1984 - 1985 Corvette: Service Bulletin: Noise in Direct Drive 4-Speed Manual Transmission

Bulletin No: 85-111

Date: Aug., 1985

Figure 1

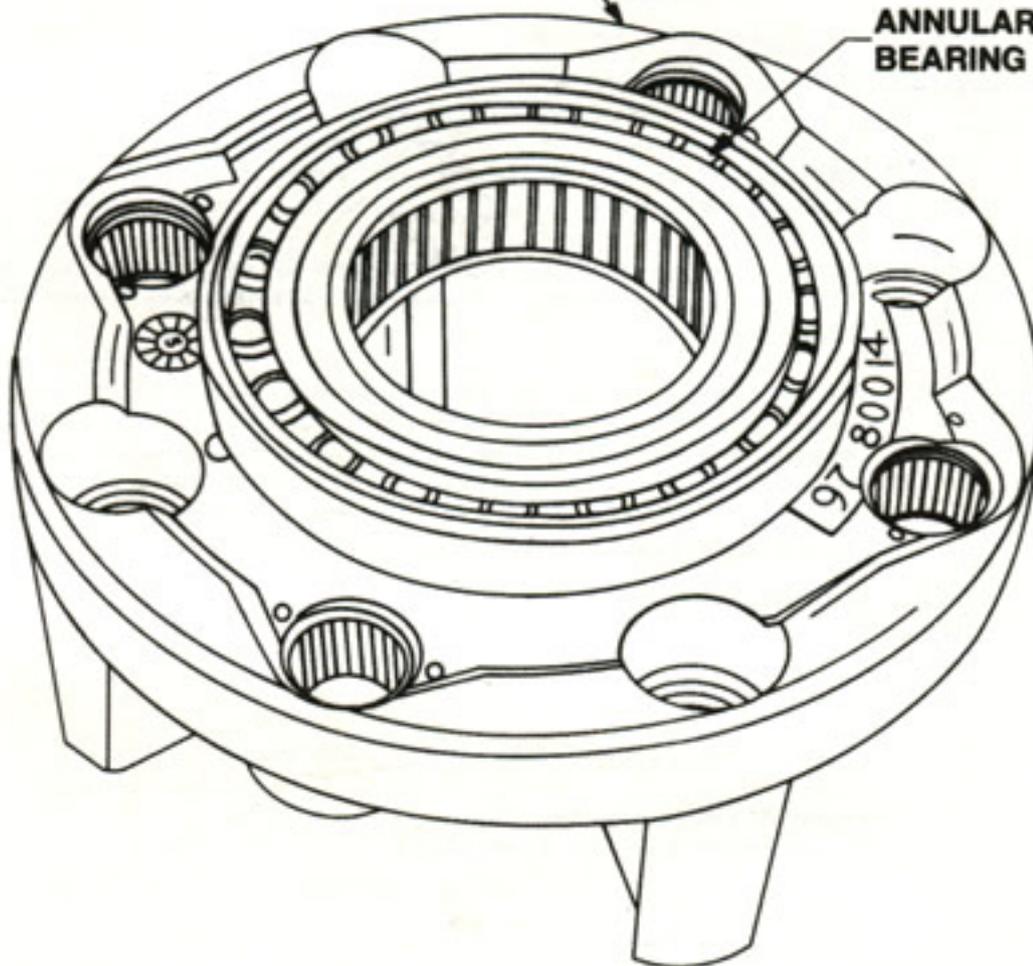
This condition may be caused by a worn annular bearing on the planetary gear carrier (see illustration). Continued operation of a noisy transmission in the direct drive model will cause damage to the planetary carrier, adapter plate, input sun gear, and input sun gear oil seal. If the input sun gear oil seal is damaged, it is possible for overdrive unit oil (Dexron II) to leak into the manual portion of the transmission.

On transmissions beginning with serial number D5C 14413 CF, a new planetary gear carrier has been released. This carrier (P/N 14094571) incorporates an annular bearing with increased thrust capacity.

1. Inspect the adapter plate surface, input sun gear, and input sun gear oil seal for damage. If there is indication of damage, the adapter plate, input sun gear, and input sun gear oil seal should be replaced. If there is no sign of damage, these parts may be reused.
2. If debris is present in the overdrive unit, completely disassemble and clean the unit, including the valve body. Thoroughly flush the cooler lines to remove any debris following the procedure outlined in the Vehicle Service Manual. Replace the oil filter.
3. If there is evidence of oil intrusion from the automatic overdrive unit into the 4-speed manual unit, the manual unit should be drained and flushed also.
4. Replace the planetary gear carrier with the new, P/N 14094571, carrier.

NOTICE: When an overdrive unit from a transmission built prior to serial number D5C 14413 CF is disassembled for any reason, it is recommended that a new, P/N 14094571, planetary gear carrier be installed to prevent potential future annular bearing failures.
